AFFIDAVIT

Planning and Environment Court

David Manteit V Brisbane City Council 2916/24

AFFIDAVIT - Response to Corrigan report

Corrigan option 2 , corrected by Manteit

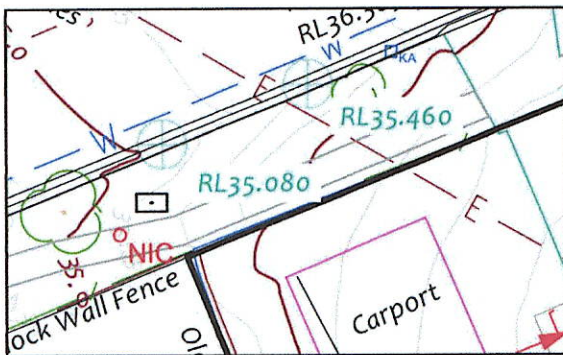
82. There is no requirement by Manteit to change the levels of the land. Corrigan proposed to flood the site, with a charged pipe, in the same way as the original illegal red line with no RPEQ certification. Who would have thought another flooded pipe. This time by an RPEQ, certified.

Corrigan system 2								
	Stub 97	Stub 98	Stub 99	Pit 4	Pit 5	Pit 6	Kerb	Cross check
FSL	37.300	37.000	36.000	36.000	35.798	35.500	35.300	
Pipe Length		20000	20000	6000	11000	8000	8000	73000 mm
New start of line invert level brought forward		36.625	36.325	35.250	35.220	35.048	34.750	36.625 m
Min .5% fall, 1% over verge		0.100	0.100	0.030	0.055	0.040	0.080	-0.405 m
Invert level end of line.	36.625	36.525	36.225	35.220	35.165	35.008	34.670	m
Prima facie depth (needs to be min 675)	0.675	0.475	-0.225	0.780	0.633	0.492	0.630	m
Pipe needs to be lowered by to make it work.		0.200	0.975	0.000	0.117	0.258	0.000	-1.550 m
Adopted pit level		36.325	35.250	35.220	35.048	34.750	34.670	34.670 m
Lawful point of discharge							35.460	
Corrigan charged system malfunction in metres							-0.790	m

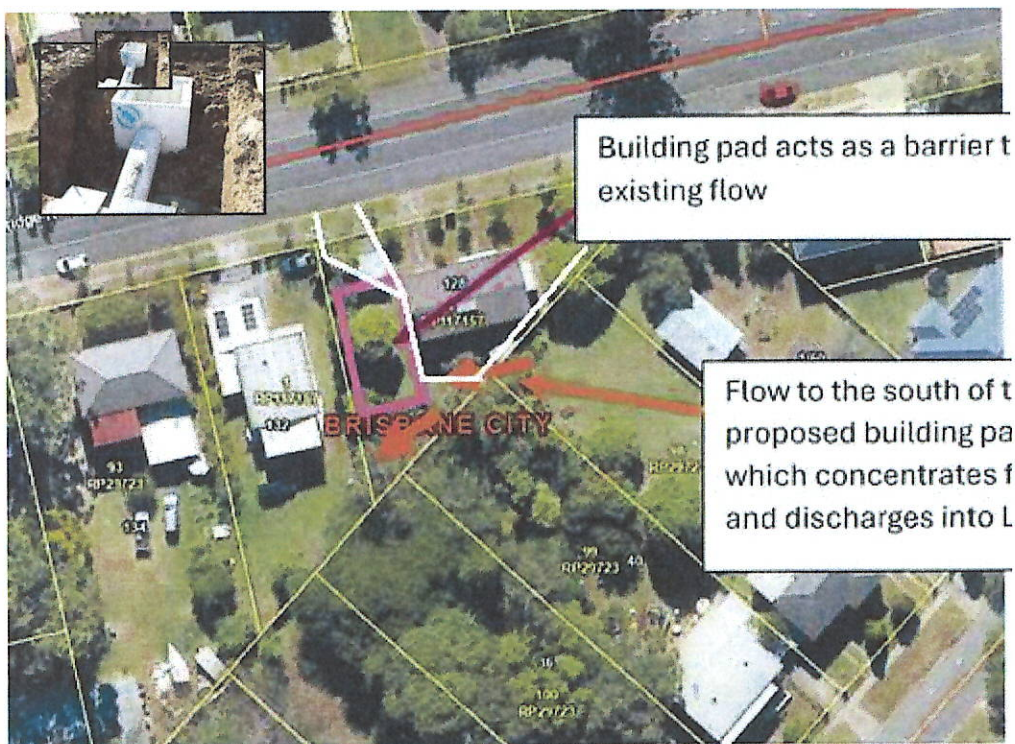
83 Corrigan plan to cause the demolition of the existing house.

84. Pipe between Lot 97 and Lot 98 will travel within 700mm of back fire escape steps. Hence part of the house would need to be demolished.

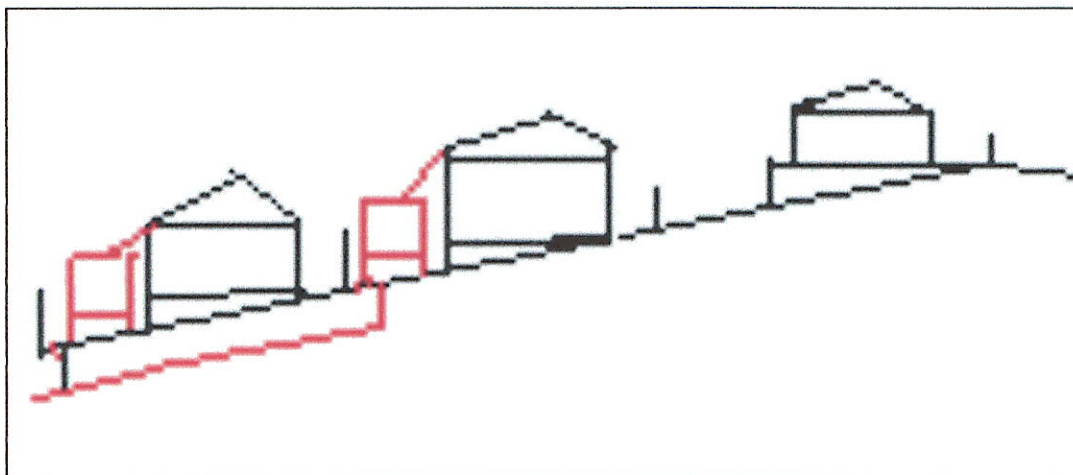
It is unsure how Corrigan can get 71.3 litres per second into 2 kerb adaptors of 30 litres capacity.

Corrigan has water tanks for 75 - 28 litres per second = 47 litres per second = 169,200 litres per hour, as per fraction impervious. This is 17 * 10,000 litre water tanks required. That's 6 water tanks required per property. 5 square metres per tank = 30 square metres gone in your backyard.

117. Corrigan has not done a reconciliation of his numbers

133. Corrigan 169,000 l/s per hour (who knows) rainwater tank plan

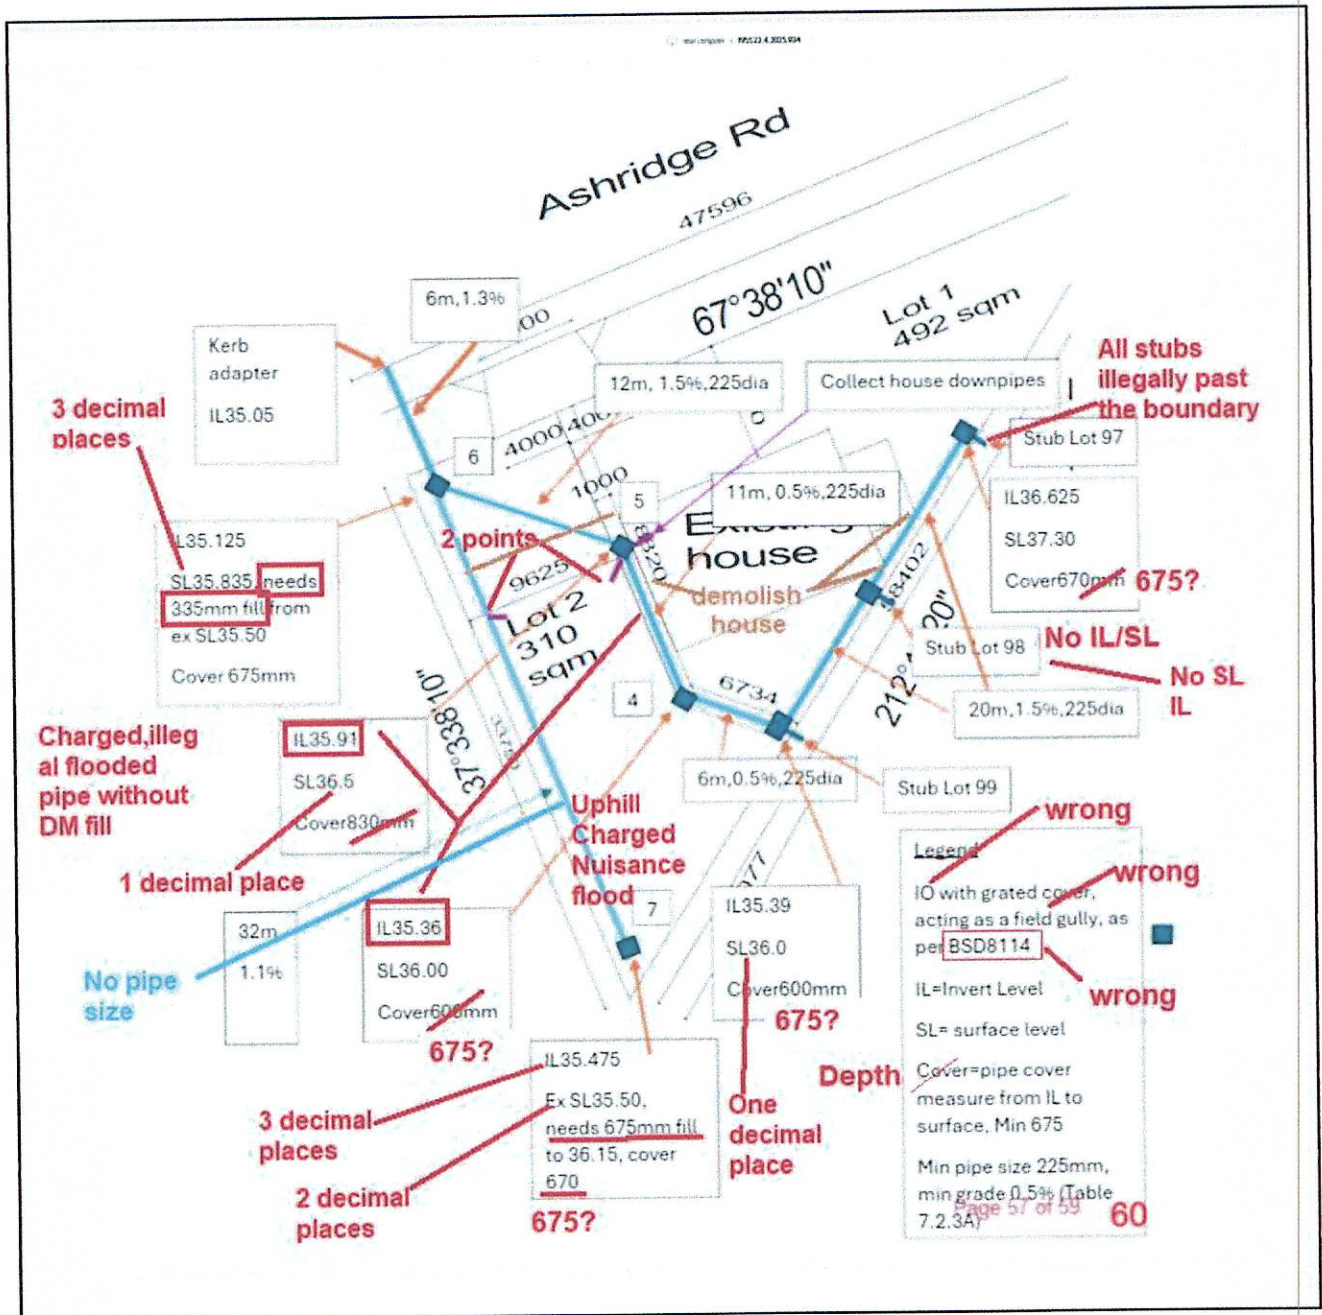
134. No detention pits drawn by Corrigan? Why not ?

135. Above - depiction of 16 water tanks that will provide water protection for one hour, when the expected rainfall comes.
